**PLANNING COMMISSION MEETING AGENDA
NOVEMBER 15, 2022
6:00 PM**

**LOCATION: CITY HALL, 301 W. CHESTNUT STREET
ONLINE VIEWING: [HTTPS://US02WEB.ZOOM.US/J/86254439985](https://us02web.zoom.us/j/86254439985)**

Plans

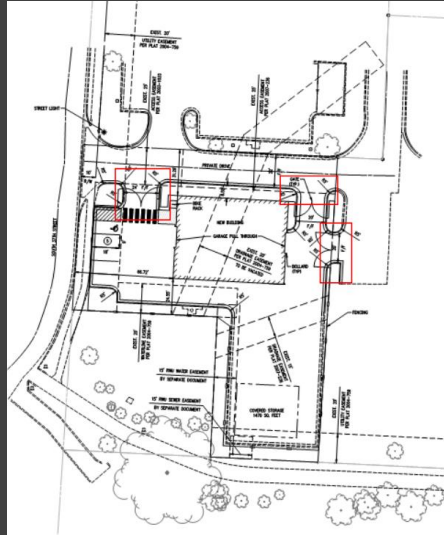
This is the site plan. Please note the facility will be completely enclosed by a fence with gated entrances. You can see the trail noted on the plans that run through the southern portion of property.

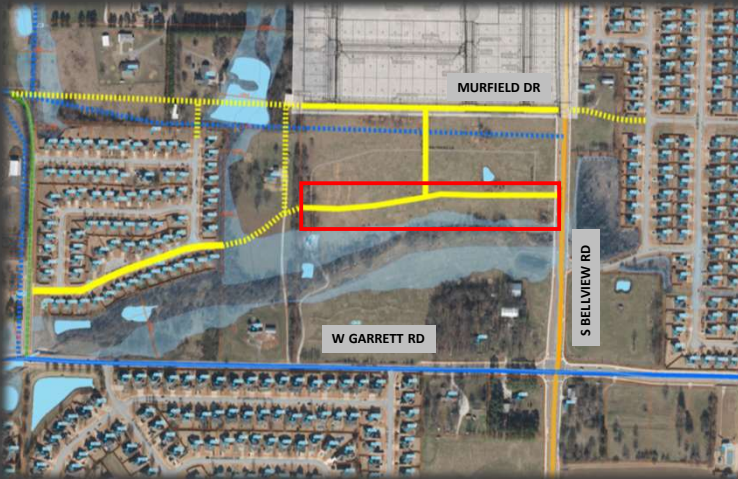
The applicant is requesting a **WAIVER** from Sec. 14-604(C) requiring minor street connections at intervals not to exceed 660 feet and not less than 200 feet along each boundary that abuts potentially developable land. The applicant states, "We are providing cross access on 3 sides of the property. We are requesting a waiver from providing cross access to the abutting south property. Cross Creek runs along this property line and would require substantial drainage structures in order to provide adequate flow conveyance. Since this property is a Zone 2 on the Karst Map and Cross Creek has been identified as a losing stream, we are requesting to leave the creek undisturbed and not provide cross access to the south."

The applicant proposes a permeable paver system which meets Stormwater management requirements. The applicant must provide a maintenance agreement to ensure perpetual maintenance and cleaning of the paver system per the manufacturer's specifications.

The applicant proposes a permeable paver system to meet Water Quality requirements.

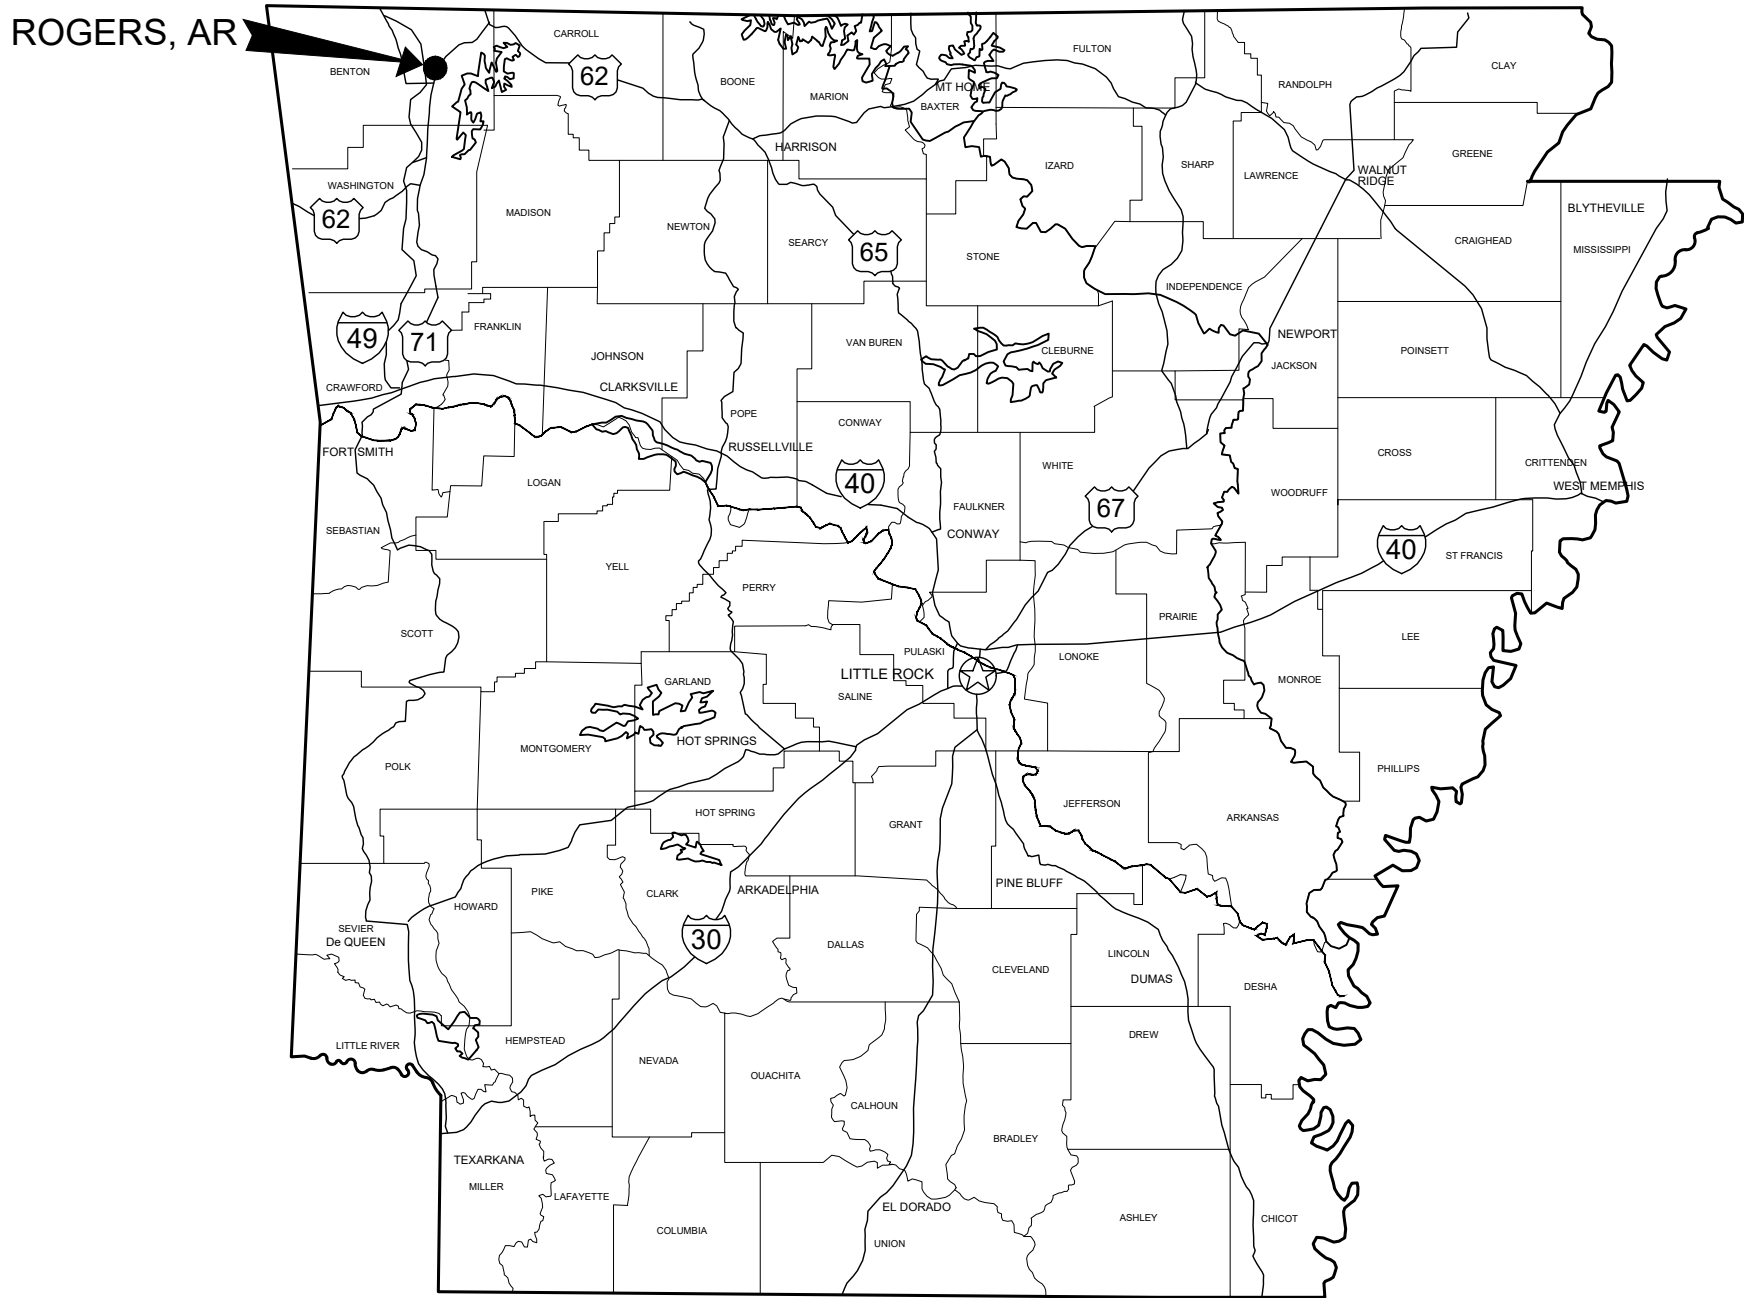
We have reviewed the Large Scale Development Plans for NWA Flight Hangar Construction. We are approving the plans with the following conditions:

2. Show the existing valve at the end of the public line to be a "Demarcation Valve". All waterlines past this valve will become private and eliminate the need for a public main extension. Also, change the tee to be a 90° elbow for this fire line with no stub out to the north.
3. Provide a profile for the Fire Line. There should be 18" of separation between the fire line and the sewer force main with water over sewer. The force main may need to be lowered and should be so noted on the profile.

Revise the plans addressing each comment and submit one pdf copy of the revised plans **directly to this office** for further review.

Changes from DCP

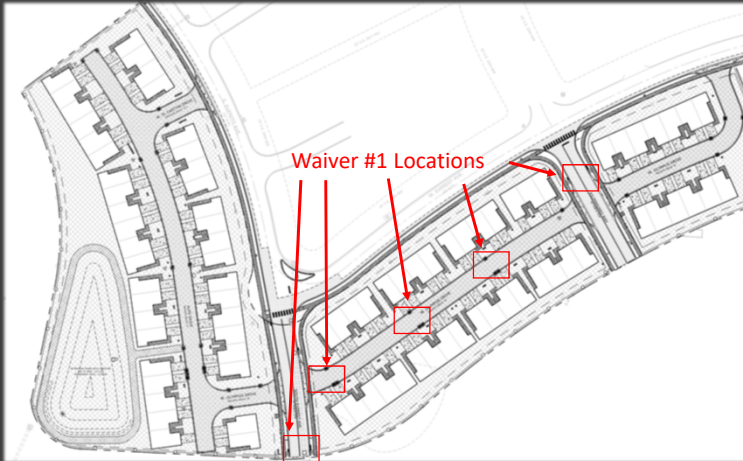
A unit on the eastern side of the development was removed by the applicant. They were not able to provide adequate compensatory storage within the special flood hazard area.

Waiver Exhibit

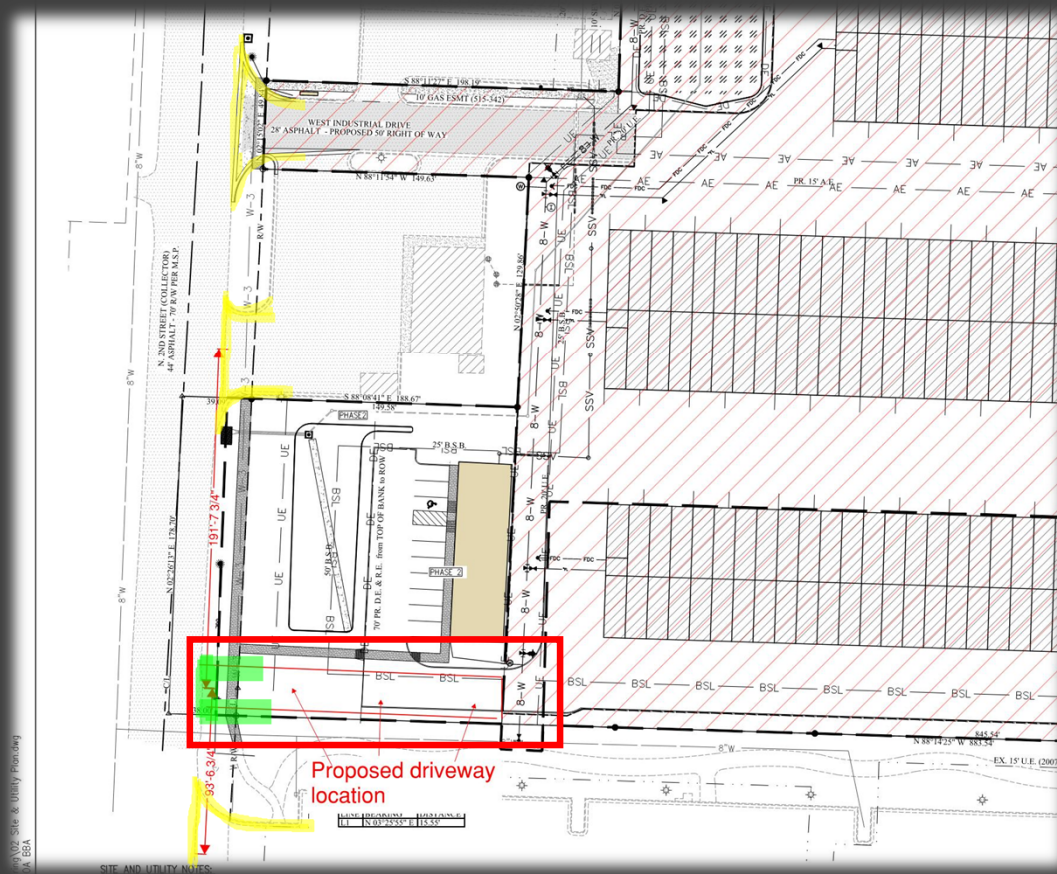
Sec. 14-260 (1)(f) requiring curb cuts on a 45 mph road to be 250' apart.

The site has an awkward layout with no visible frontage, and the applicant believes one access point is not sufficient.
